> SKPR2020.15-Sketch Plan Review #1 Re:

> > Applicant Imperial Mills' Responses Staff Sketch Plan Review Letter dated

IMPERIAL MILLS - TECHNICAL DATA SHEET

BELMONT, NC

IMPERIAL MILLS - BY RIGHT SKETCH PLAN

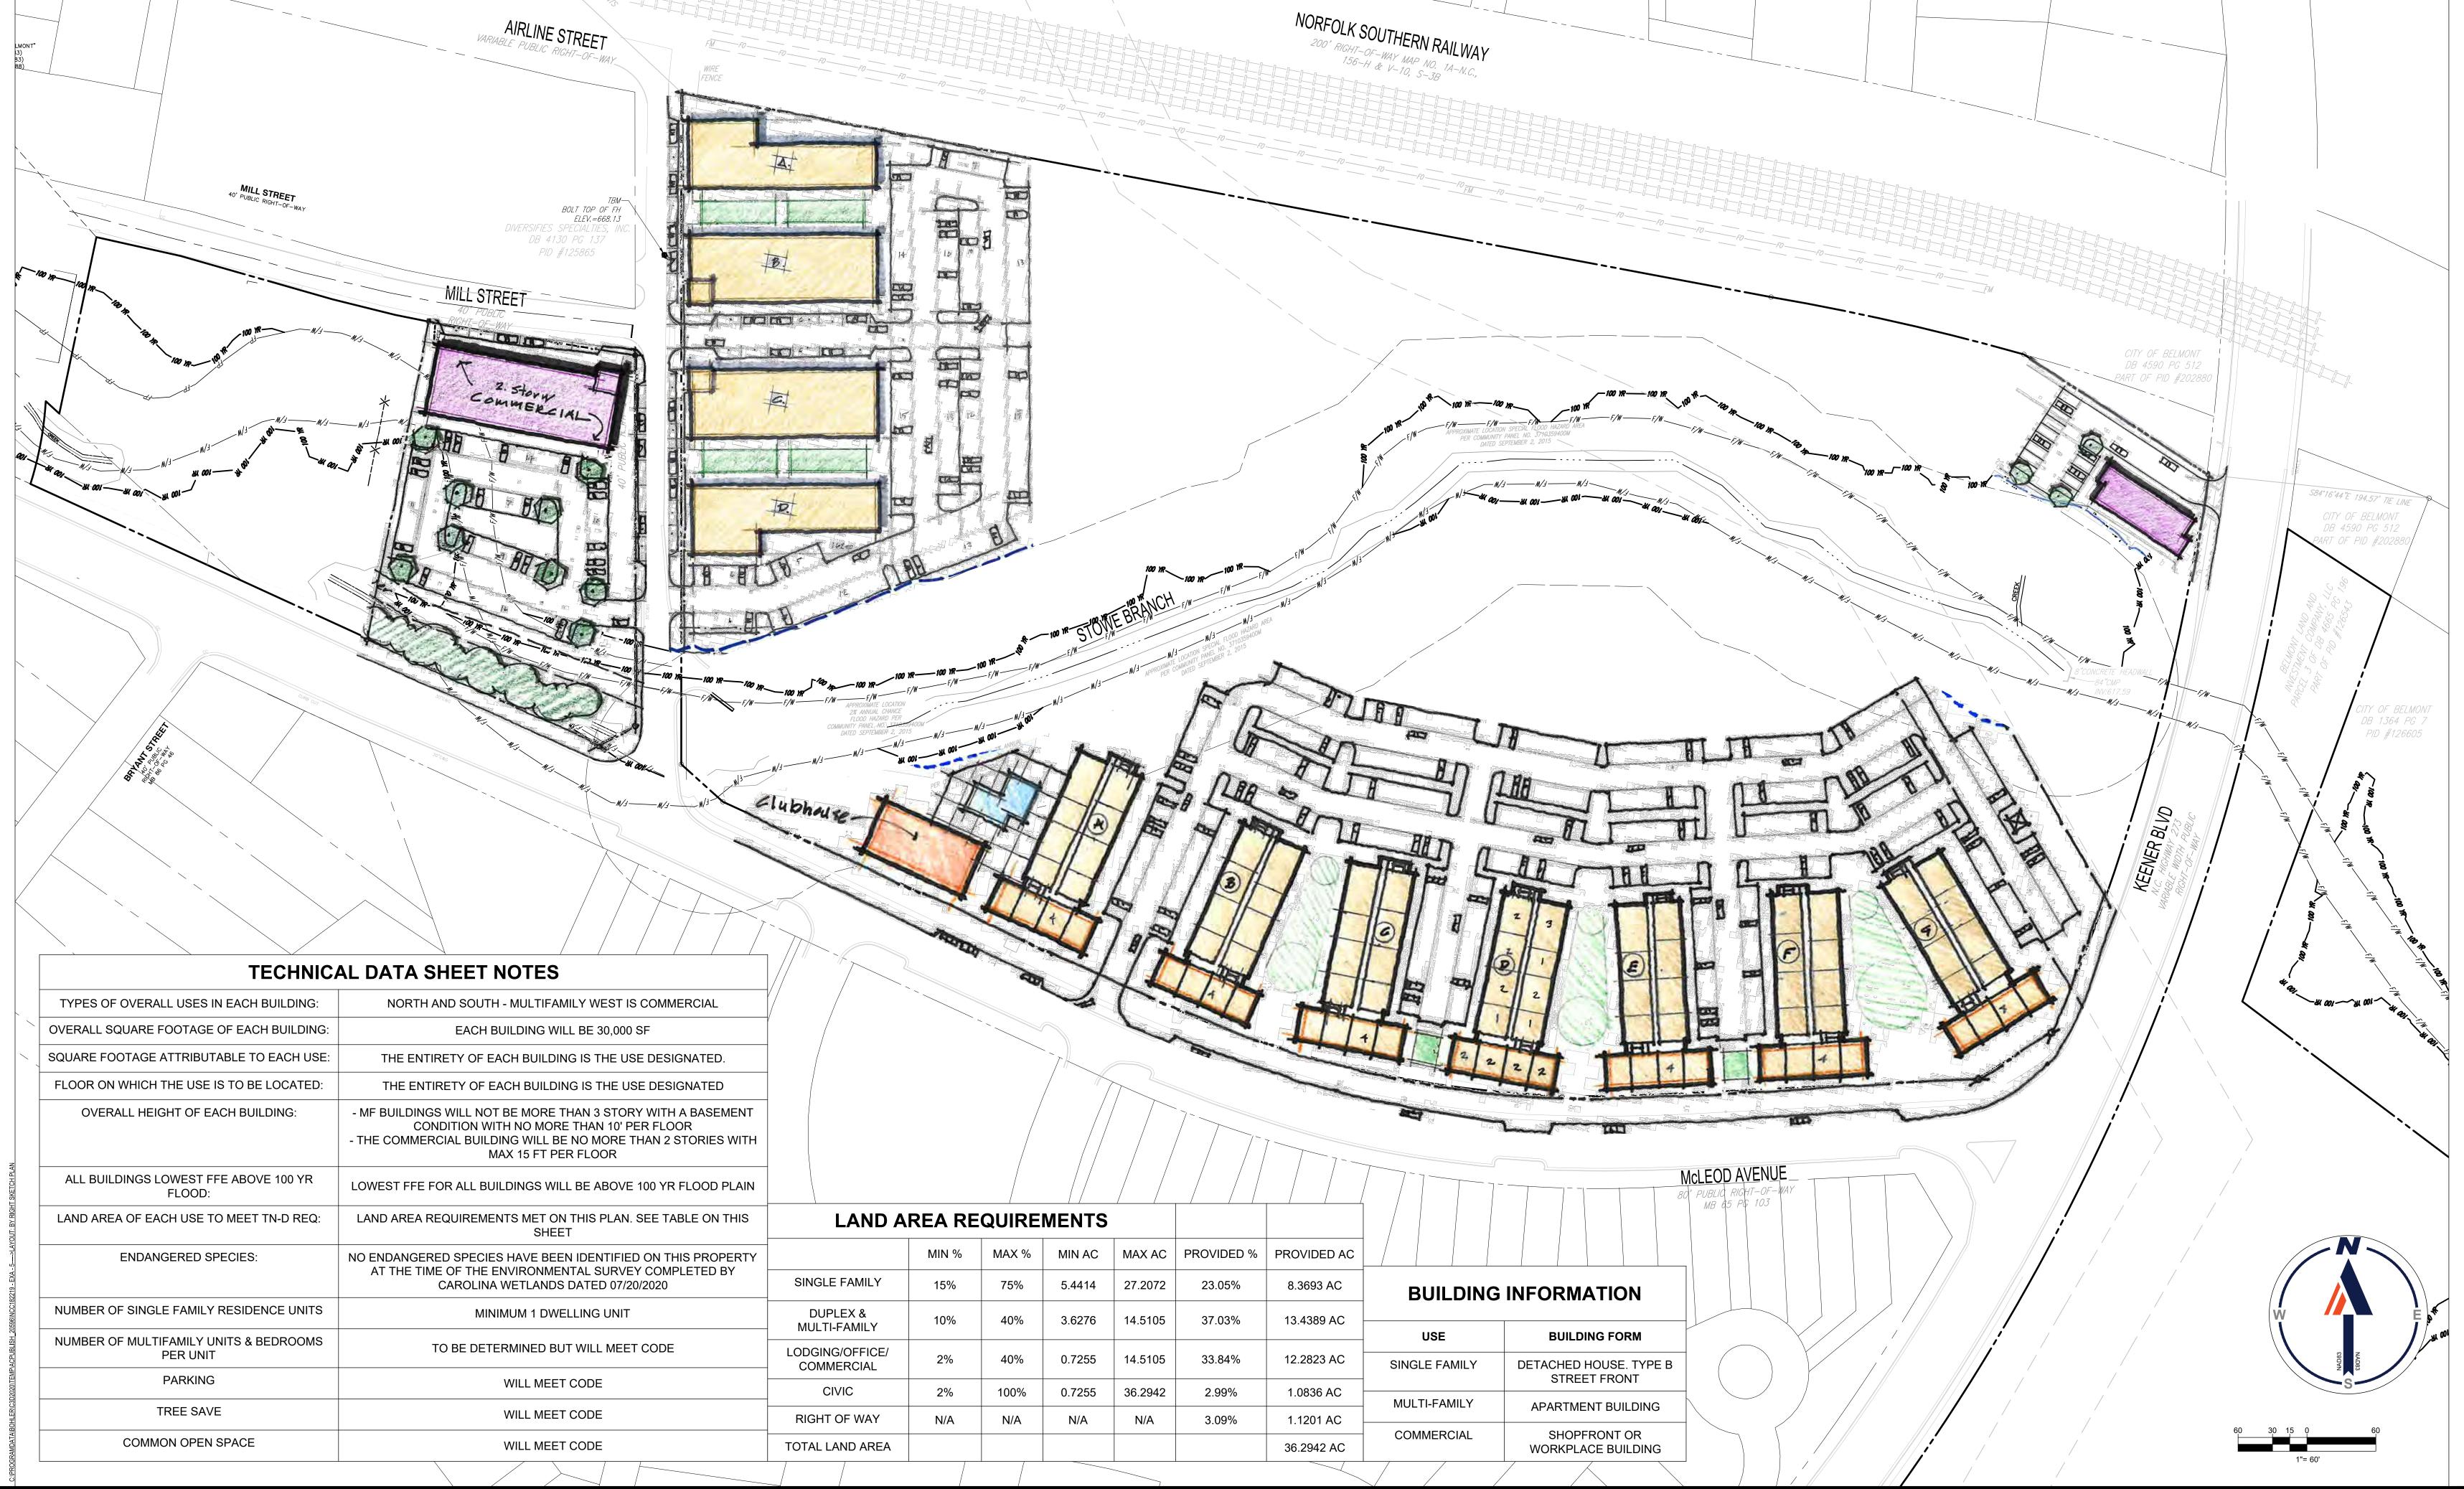
- a. No new street or entrance is allowed within 100' from an existing corner per NCDOT.
- b. Entrance to multifamily along McLeod needs to align with entrance to Hawthorne Park Avenue.
- c. Additional access point needed along McLeod for multi-family units, unless street infrastructure is connected with the multifamily component on the other side of Stowe Branch.
- d. Staff does not believe the location indicated for SFR dwelling is feasible due to guardrail along Keener and topographic conditions. Applicant is responsible for confirming that a driveway permit for this dwelling is both constructible and allowable at the location indicated by NCDOT.

<u>Response/Action</u>: See Revised Sketch Plan for Tract 1. Additional access could be provided with easement from Hawthorne Street.

ILLUSTRATIVE IMAGE OF CIVIC AREA
AS SEEN FROM VINE STREET

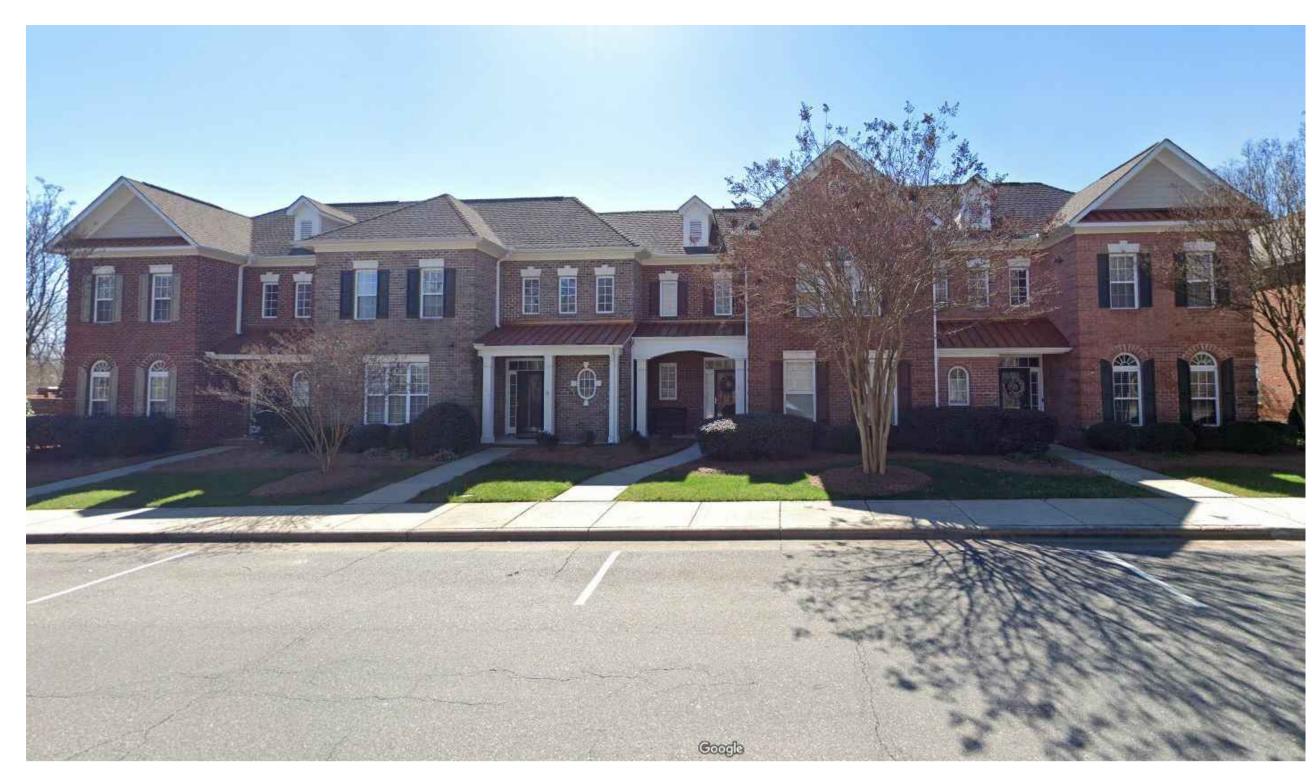
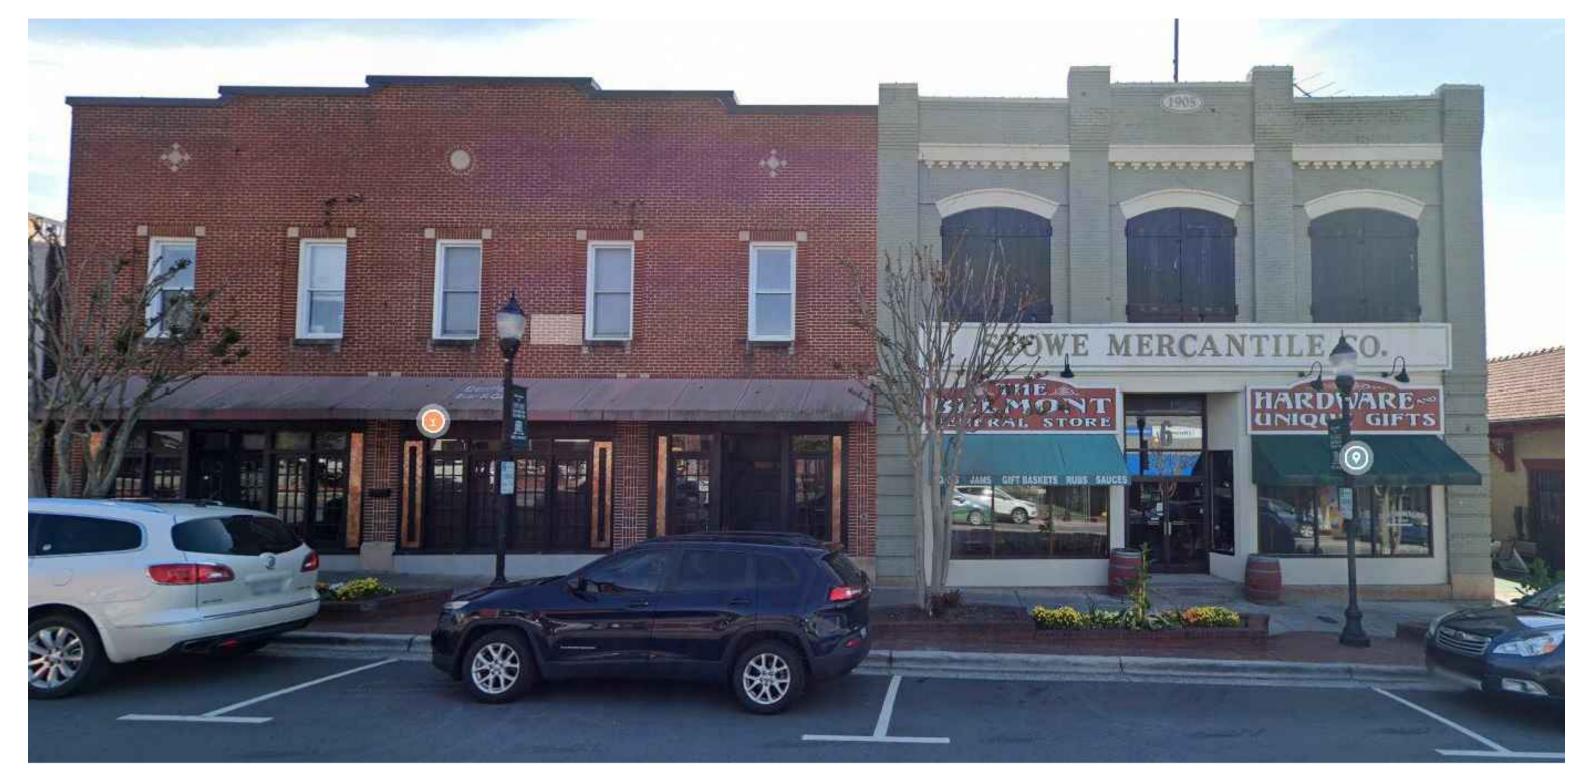
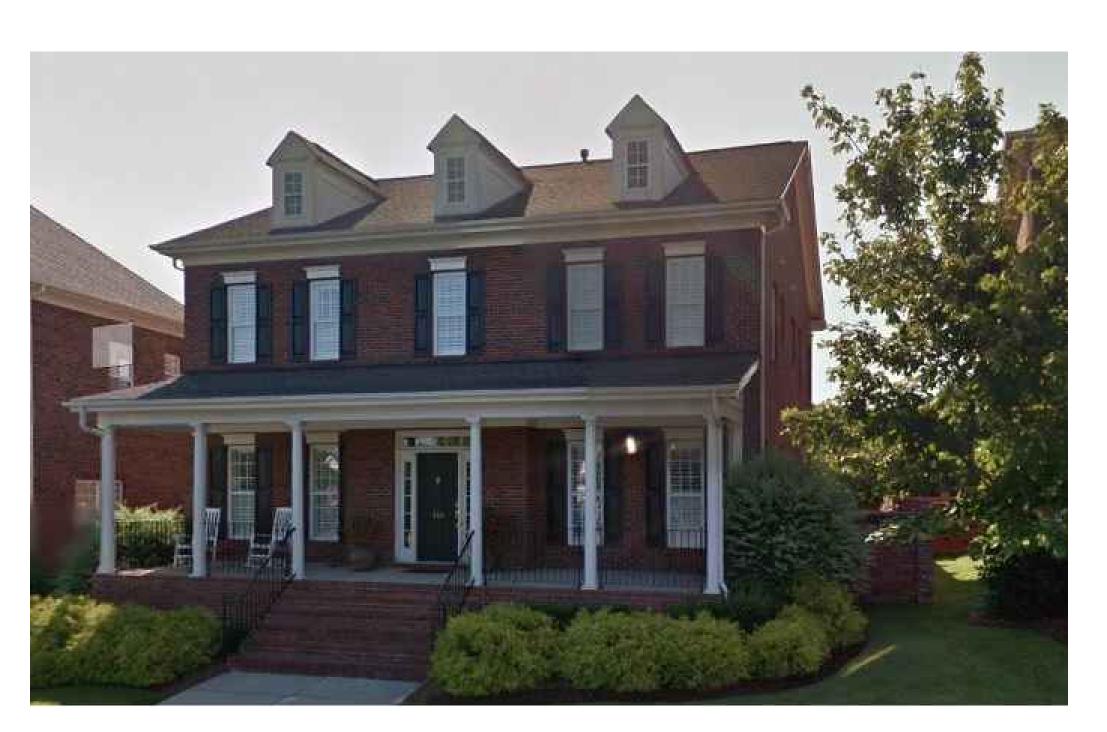
5. **Architecture:** Buildings should be designed in a way that adheres to the existing pattern of the surrounding neighborhood and meet all requirements outlined in Chapter 4 for each building form type.

6. **Civic Uses:** Per Chapters 2.2 and 4.8, civic uses are intended to serve as public gathering spaces, and include governmental offices/buildings, places of worship, schools/universities, and non-profit or charitable organizations. The civic use gross land use allocation requirement within TN-D is not met by areas designated as common public open spaces with no built improvements or private community amenities such as pools and clubhouses.

Response/Action: Please see revised illustrative Building Elevations.

Response/Action: Applicant proposes either a building for the provision of concessions to be manned by various organizations, including non-profits and charities, or alternatively, to provide public restroom facilities, for the refreshment and convenience of the public attending games or other events at Rodden Ballfield, said facility to be located in the approximate location as shown on Tract 3 of the revised Sketch Plan, and as generally depicted in the revised Illustrative Elevation Exhibit.
